RE: Minor Mine site modification – Generator Building, Canyon Fuel Company, LLC, Skyline Mine, C/007/0005, Task ID: 5456

Title: Bond modification, Generator Building

Addition of a Generator Building; Task ID: 5456

CAD FILE: P:\PERMITS\SKY\...\3.2.1-1_...
DWG. NO.: 3.2.1-1_REV16

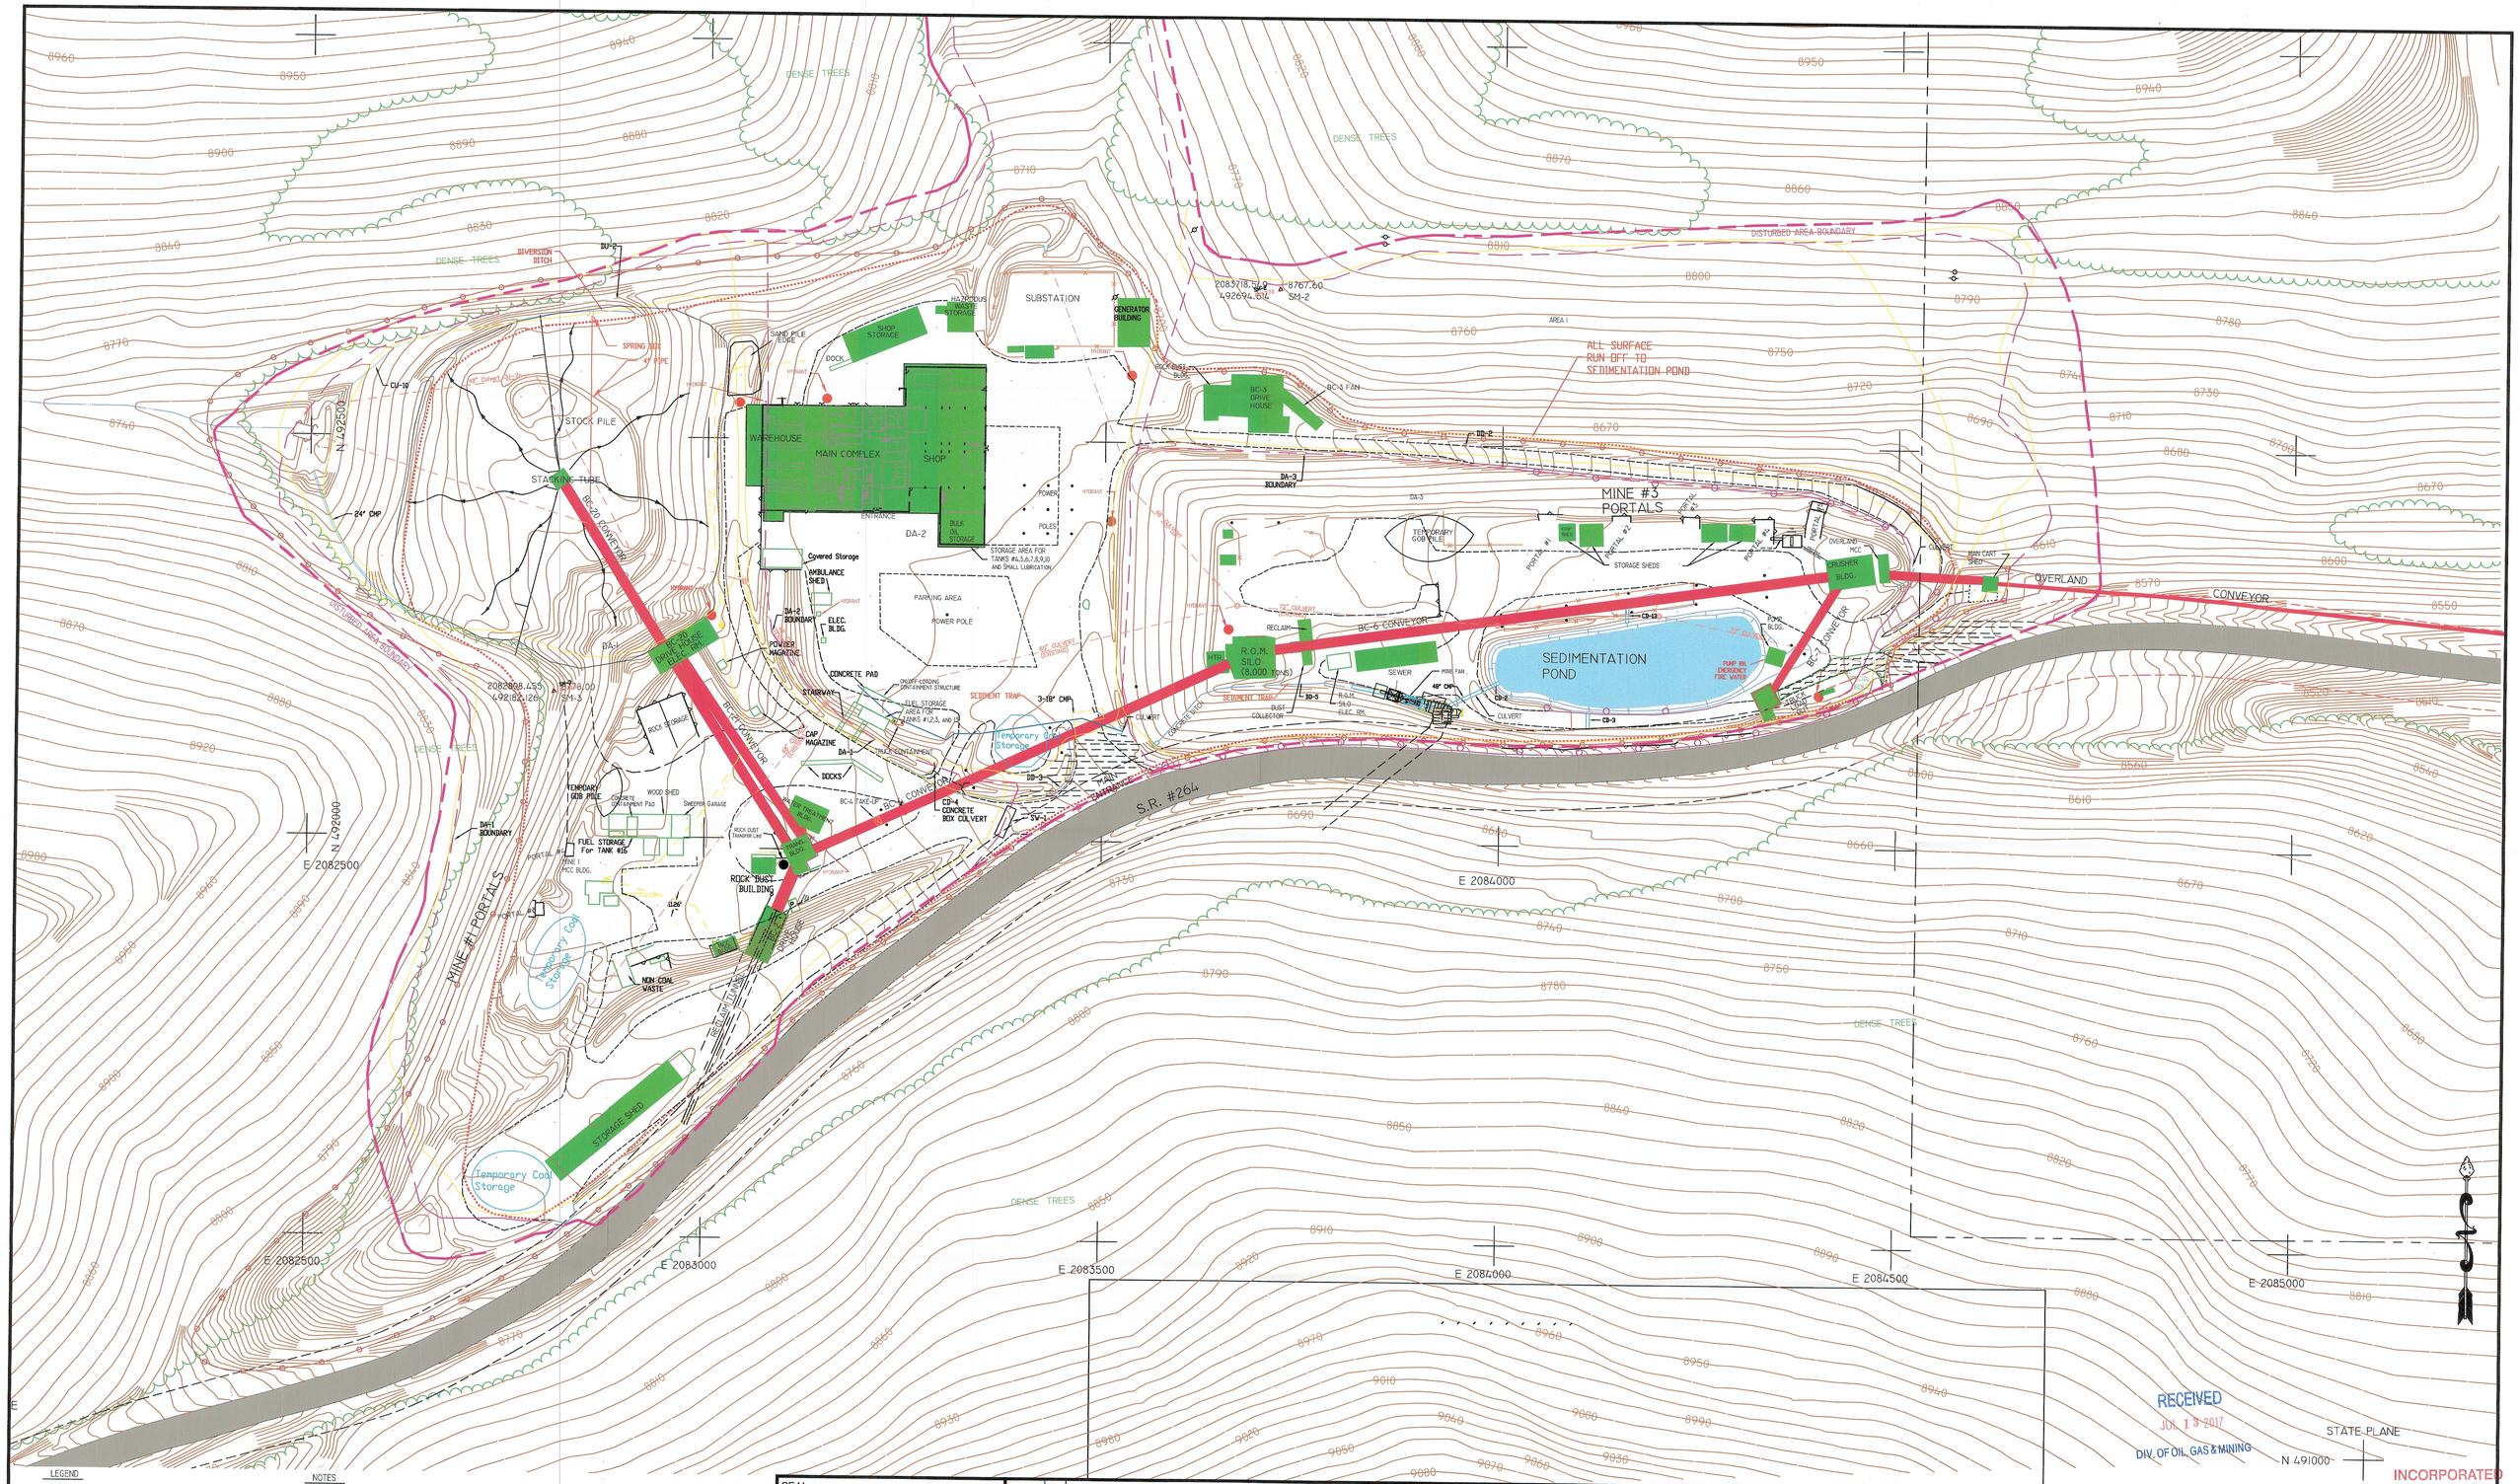
Attached to this letter is information necessary to add an enclosed steel building to hold two (2) portable emergency generators. The building would be a basic 40 x 60 x 16 foot steel enclosure including a cement floor with 2-foot high foundation walls. The building will be located immediately east of the existing substation within the existing disturbed area. Included in the application are an updated Surface Facilities map (Plate 3.2.1-1_Rev16_5-17-17) showing the location of the new structure, and modified bond sheets to accommodate demolition/removal of the building. The direct costs of demolition of the building are calculated to total $14,226, with indirect costs calculated at $3814. The reclamation costs to demolish and remove the building are calculated to increase the demolition costs by a total of $18,040. There is adequate funding in the current bond to cover this modification.

DESCRIPTION OF MAP, TEXT, OR MATERIAL TO BE CHANGED
☐ Add	☒ Replace	☐ Remove	Chapter 4, Section 4.3, Bond Total page, Demolition Total Page, Shop Warehouse 01 page (3 total sheets)
☐ Add	☒ Replace	☐ Remove	Chapter 3, Plate 3.2.1-1rev. 16
☐ Add	☐ Replace	☐ Remove	
☐ Add	☐ Replace	☐ Remove	
☐ Add	☐ Replace	☐ Remove	
☐ Add	☐ Replace	☐ Remove	
☐ Add	☐ Replace	☐ Remove	
☐ Add	☐ Replace	☐ Remove	
☐ Add	☐ Replace	☐ Remove	
☐ Add	☐ Replace	☐ Remove	
☐ Add	☐ Replace	☐ Remove	
☐ Add	☐ Replace	☐ Remove	
☐ Add	☐ Replace	☐ Remove	
☐ Add	☐ Replace	☐ Remove	
☐ Add	☐ Replace	☐ Remove	
☐ Add	☐ Replace	☐ Remove	
☐ Add	☐ Replace	☐ Remove	
☐ Add	☐ Replace	☐ Remove	
☐ Add	☐ Replace	☐ Remove	
☐ Add	☐ Replace	☐ Remove	
☐ Add	☐ Replace	☐ Remove	
☐ Add	☐ Replace	☐ Remove	
☐ Add	☐ Replace	☐ Remove	
☐ Add	☐ Replace	☐ Remove

DATE	No.	REVISIONS	MADE BY	CHK'D BY
10/27/14	11	ADDED CU-2a 48"CULVERT	GAG / CWB	
04/22/15	12	ADDED 2 NEW SURFACE SHEDS	GAG / CWB	
09/16/15	13	ADDED SWEEPER GARAGE	GAG / SLB	
8-1-16	14	ADDED Fuel Bay Catwalk;BC-4Take-up slab. REMOVED 30Kgal. propane tank	GAG / GAG	
10/18/16	15	ADDED Warehouse covered yard storage	CWB / GAG	
5-17-17	16	ADDED Generator Building
